ARCHITECTURAL REVIEW BOARD WORK SESSION AGENDA

Agenda Item: APPLICATION FOR SIGNAGE, ARB #25-003, to consider an application for freestanding signage for the commercial property located near 139 Spring Street, Herndon, Virginia, on property established by Declaration of Sunset Business Condominium recorded in Deed Book 5876, page 13, among the Land Records of Fairfax County, Virginia.

STAFF REPORT

Agenda Item: ARB #25-003; Signage; Unit Owners Association of Sunset Business Park Condominium, adjacent to Fairfax County Tax Map 0173 09 0007, near 139 Spring Street

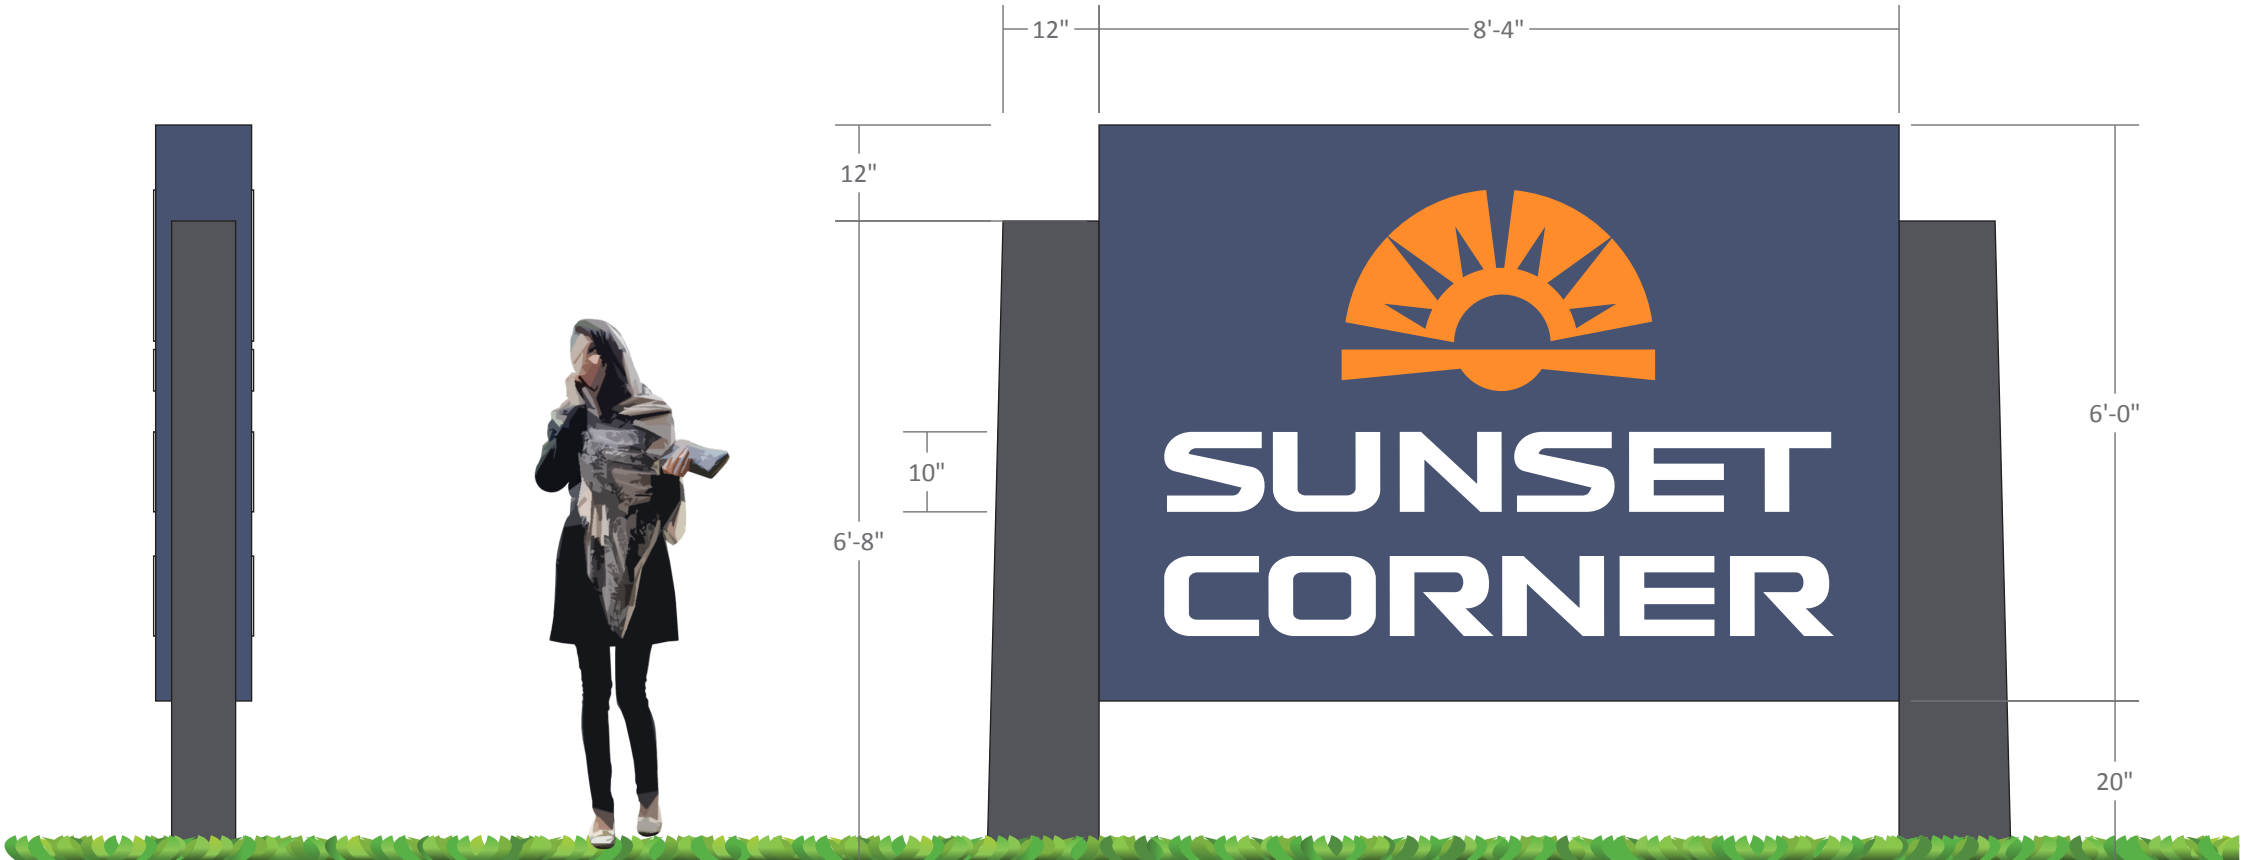
Note: This application is only to consider the installation of a monument sign at location #1 (circled below).
